#### DESIGN REVIEW BOARD WORK SESSION

## Design Review Board Case # 2020-0001 Block P – 765 John Carlyle – North Tower and Podium

**Purpose of Application:** Final review of north office tower and podium.

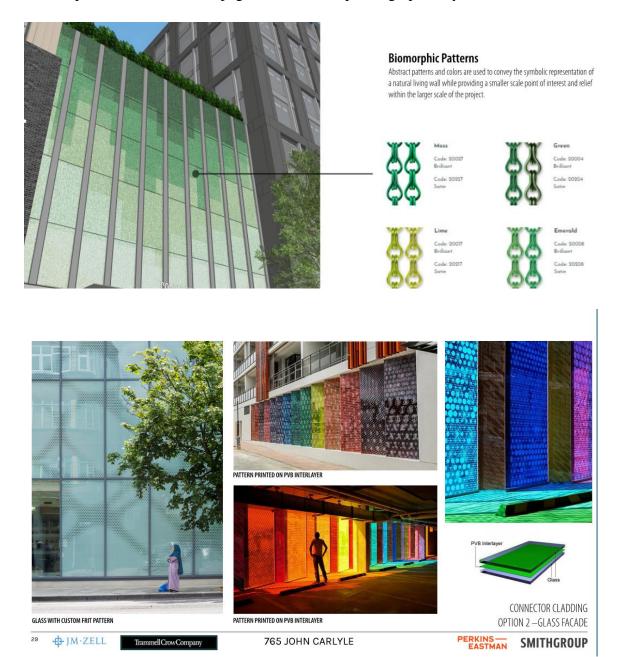
Site constraints and previous approvals dictate that parking ascend above grade on Block P. Never the less, the proposed office tower will be full story shorter than the original approval, as the applicant has removed one (1) level of structured parking, as intimated above. Generally speaking, the screening at the podium level, P2 – P5, is bifurcated into either glazing, or metal systems. More specifically, glazing is used to conceal the first two levels to the parking, which is setback slightly from the r3etail base in plan, from the retail level, while the remaining upper floors (P4 – P5) are concealed by a perforated metal panel, similar to the approve design for the south tower. This design uses various systems of aluminum/steel to recall the typical expression of a window. However, as intimated, the accompanying detail requires reconciliation.
